DODGE 48RE VALVEBODY HYDRAULIC DIFFERENCES

CHANGE: Beginning at the start of production for the model year 2003, the 48RE transmission was introduced to the Dodge line of Heavy Duty trucks. The 48RE is a new designation for the previous design 46/47RE. There are numerous differences as far as a re-designed pump Stator and Torque Converter as well as increased capacity in the clutch drums. There was also a change in the hydraulics in the Valvebody in the Torque Converter Clutch Control circuit.

Figure 1

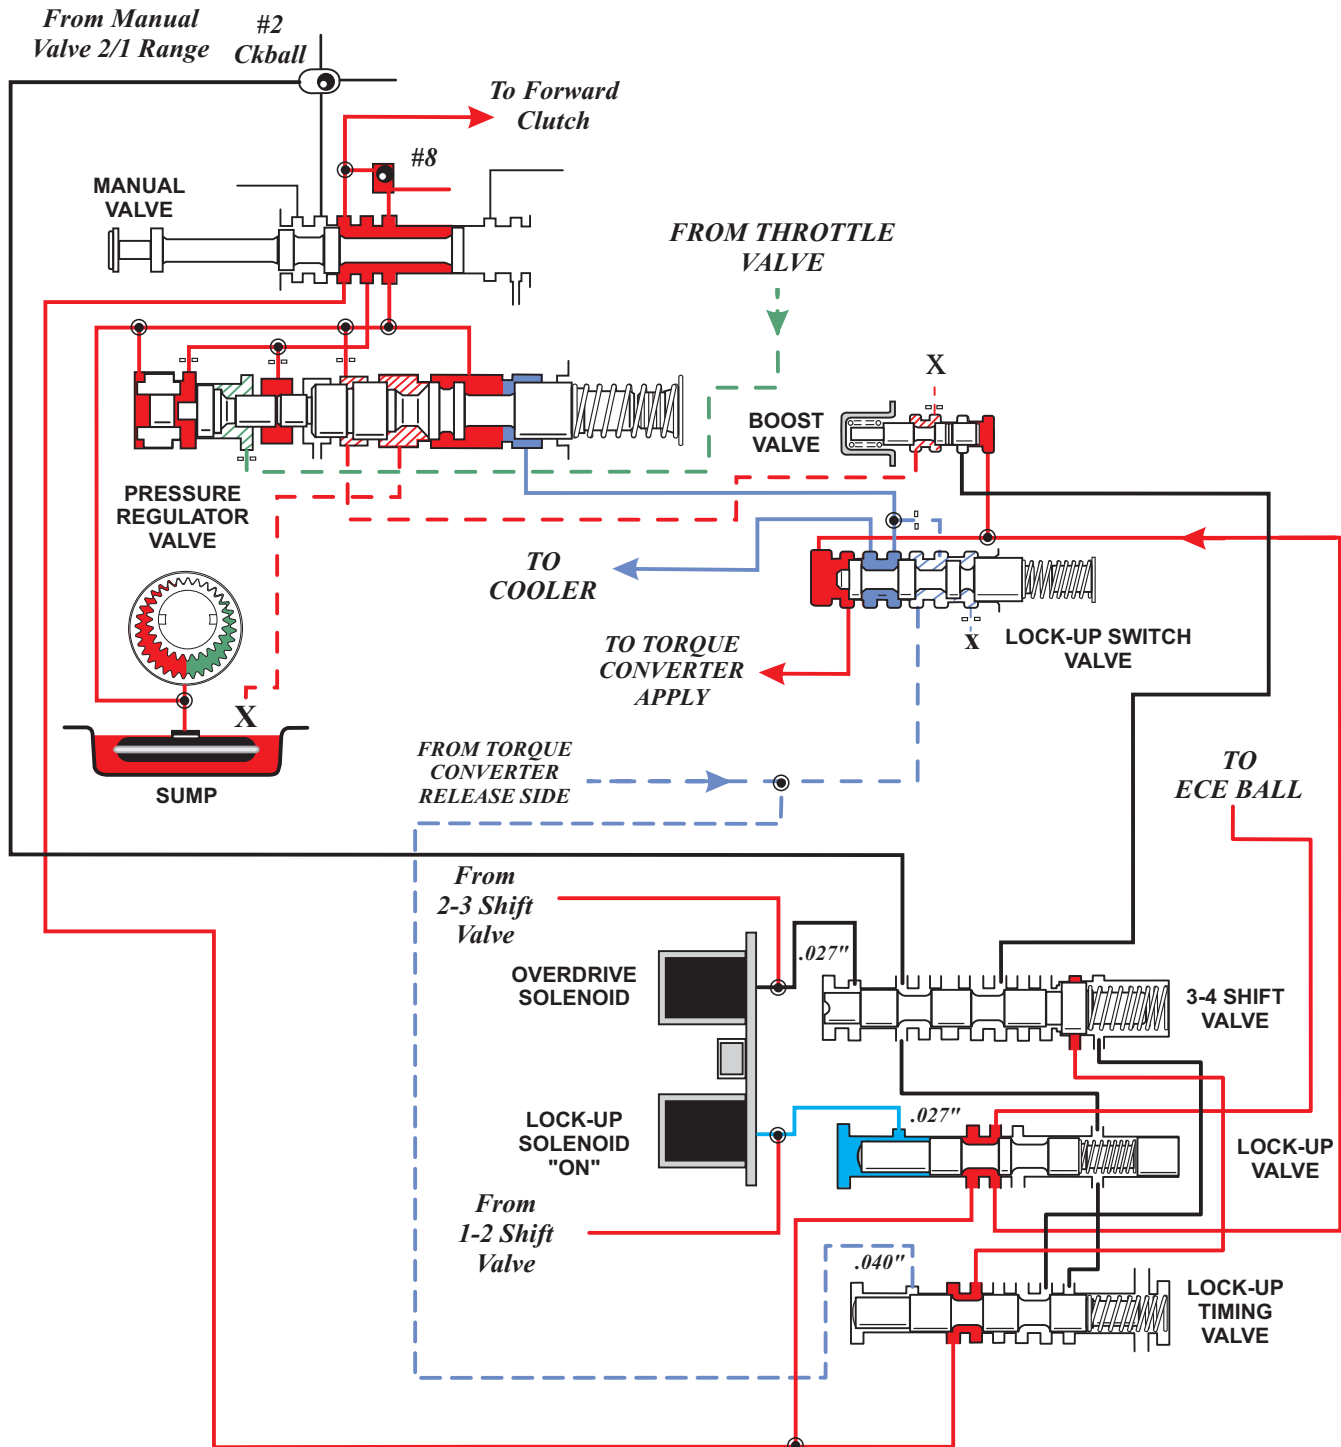
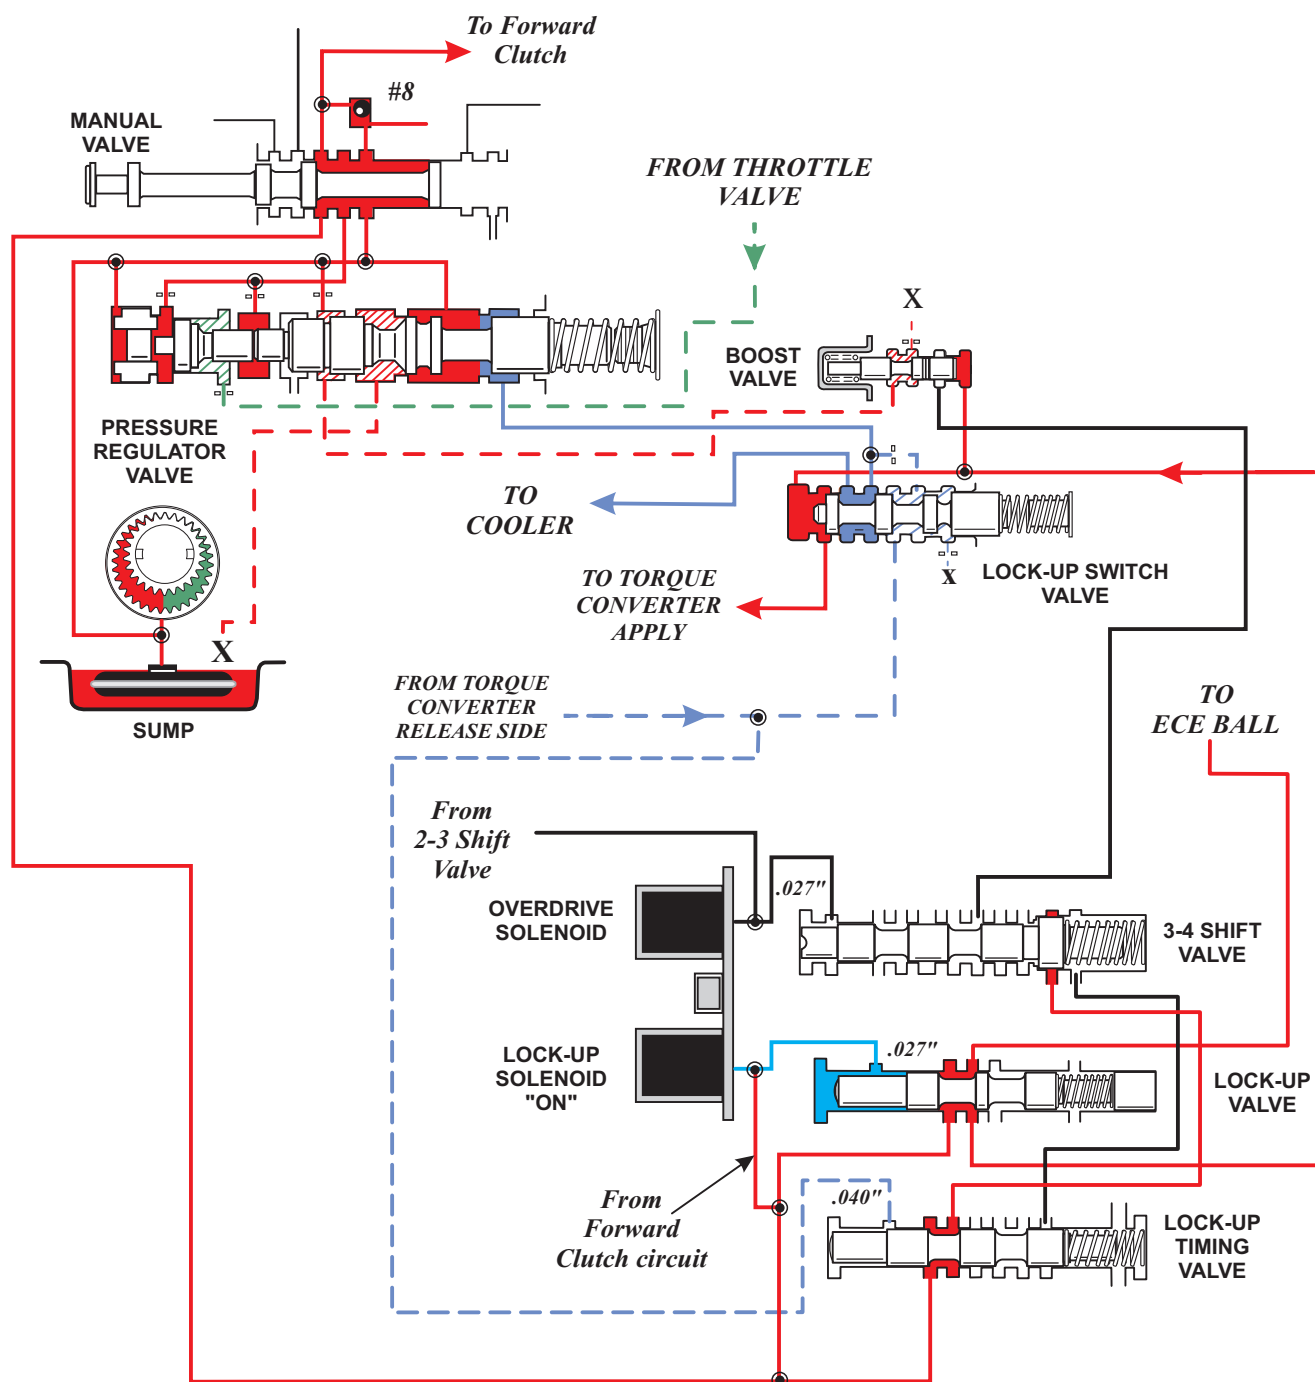
REASON: The reason for the change in the Torque Converter Control Circuit is so that TCC engagement will be possible in the Manual 2 and Manual 1 position, providing better pulling capacity at lower engine rpm. The TCC Solenoid is now fed Forward Clutch pressure instead of the previous design, that was fed from the 1-2 shift valve. This now makes it possible to have TCC in 1st gear. Refer to Figures 1 and 2 for a partial hydraulic circuit diagram of the TCC circuit.

Note: The number 2 Checkball, on 46 and 47RE, is used for a 3-2 manual downshift and for TCC cancel in Manual 2 and Manual 1 ranges, by applying line pressure from the Manual valve to the spring side of the Lock-up and 3-4 Shift Valve, and second land of the Lock-up Timing Valve to Prevent application.

Note: The Number 2 checkball is eliminated on 48RE, this will make it possible to have TCC apply in Manual 2nd and Manual 1st.

46RE/ 47RE MAIN VALVE BODY AND TRANSFER PLATE "UPPERSIDE"

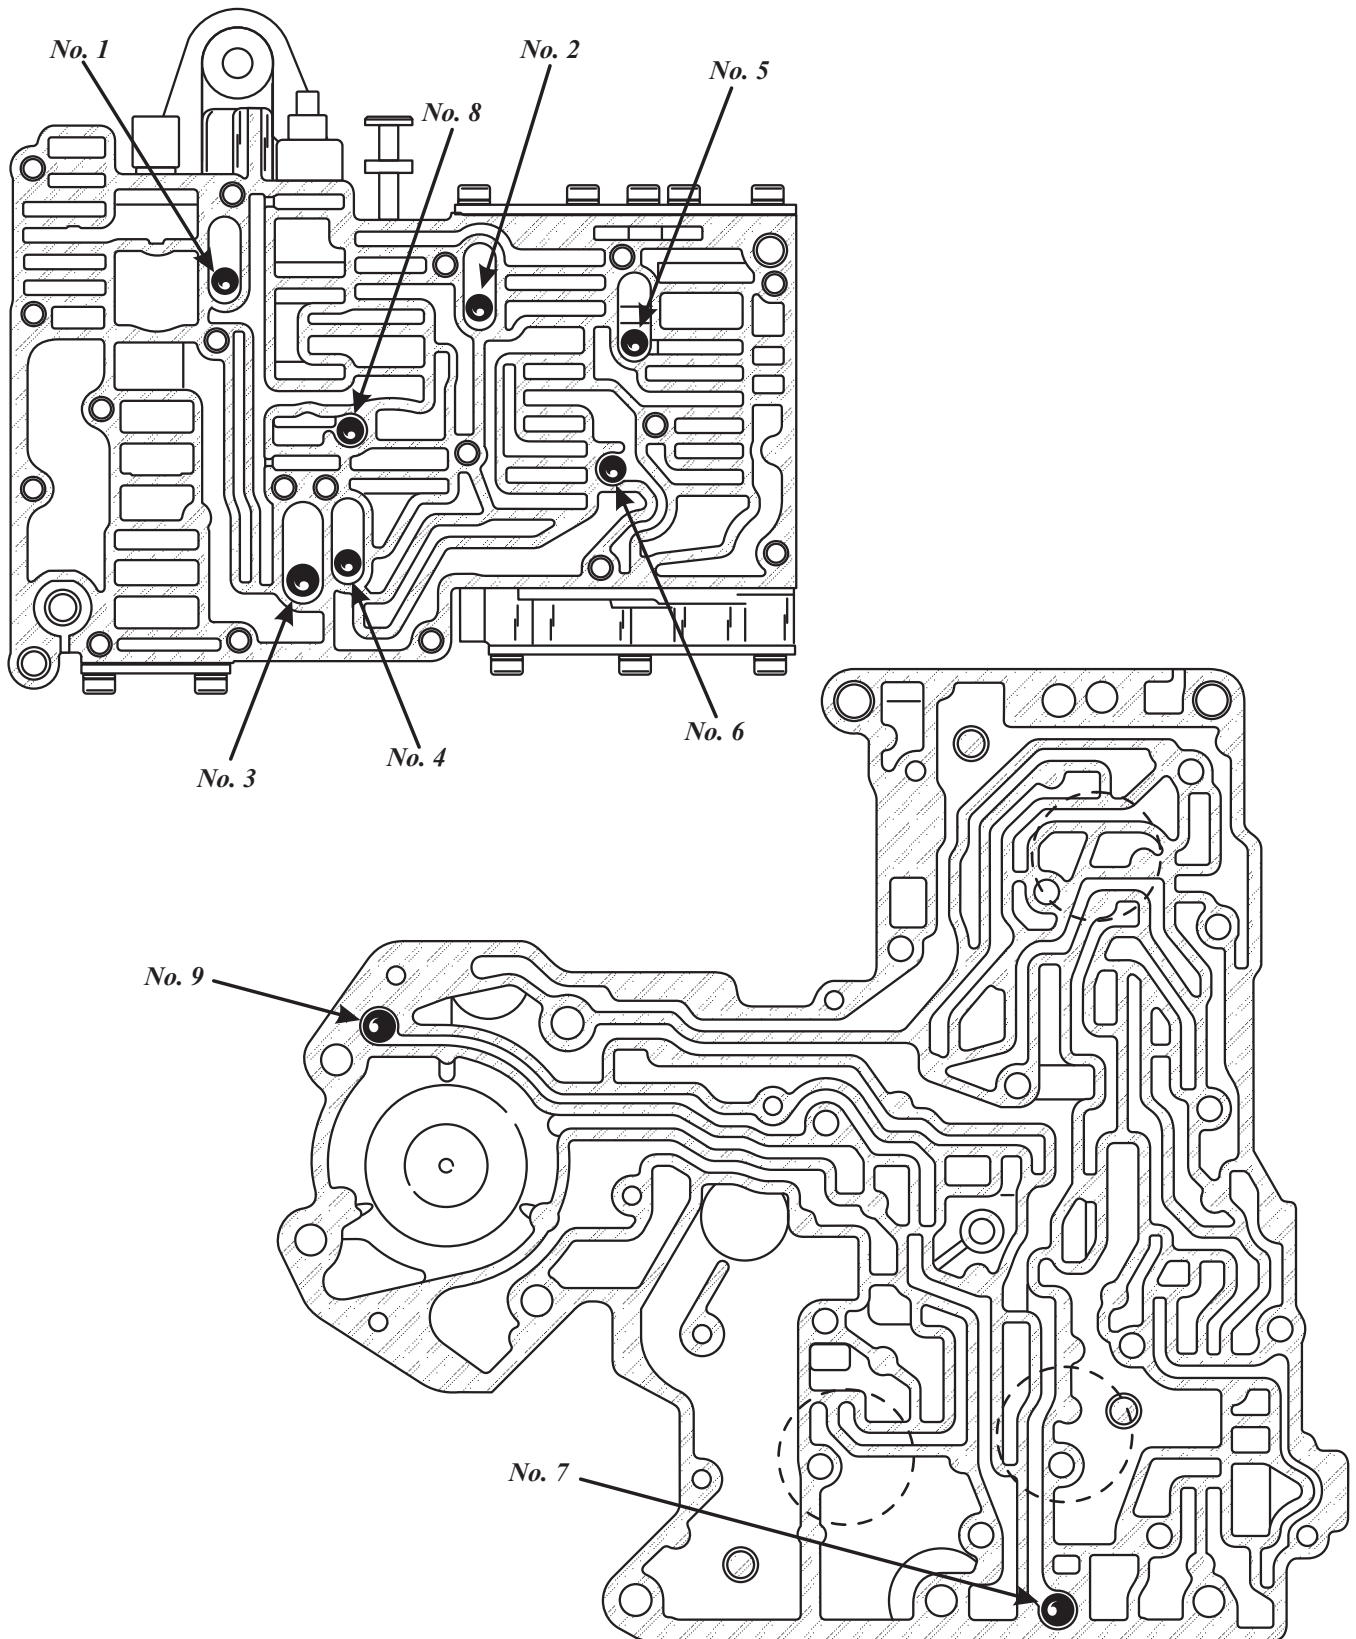
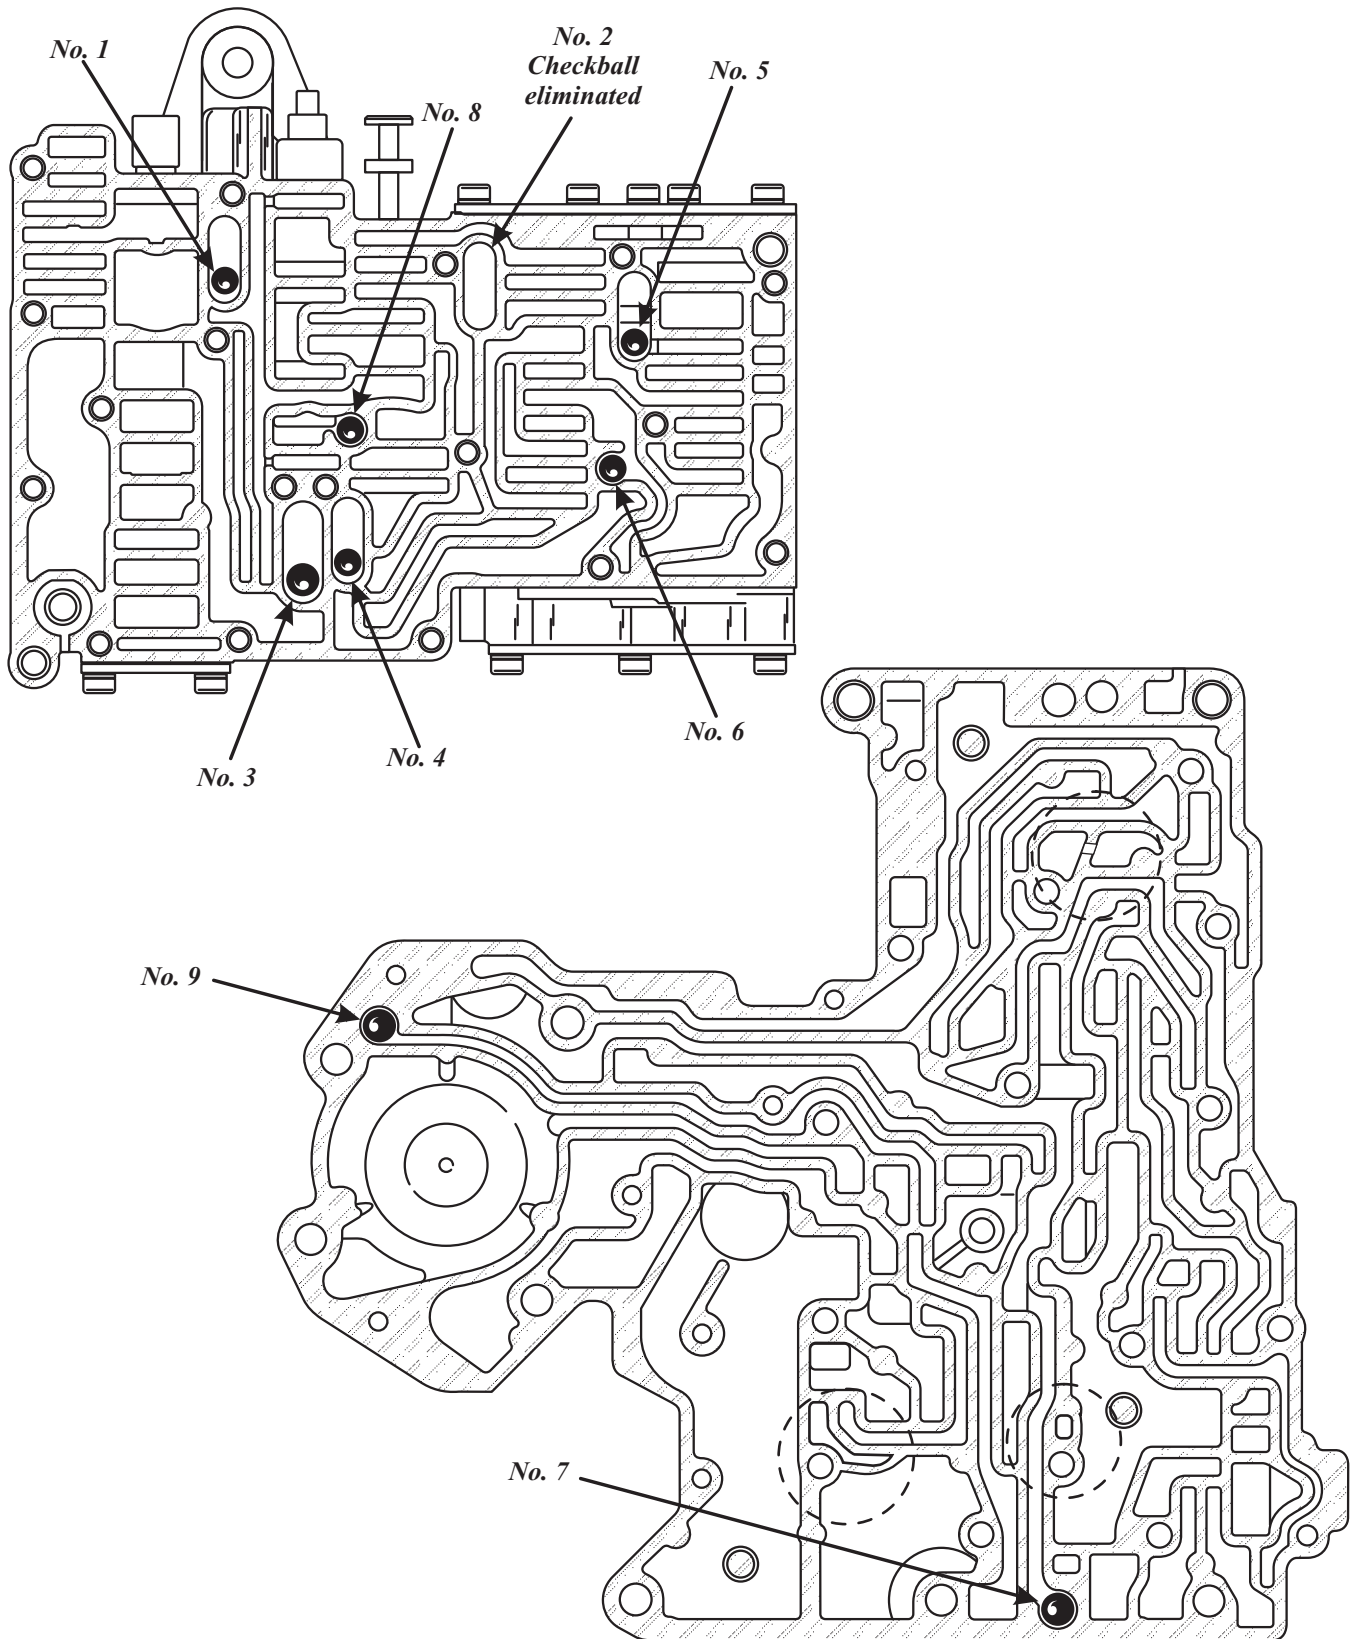
Refer to Figure 3 for a view of the previous design 46RE/47RE Main Valvebody and Upper Transfer Plate and checkball locations. There is also dotted circles around the areas that changed in the 48RE.

Refer to Figure 6 for a view of the new design 48RE Main Valvebody and Upper Transfer Plate and checkball locations, notice the elimination of the Number 2 checkball. There is also dotted circles around the areas that changed in the 48RE.
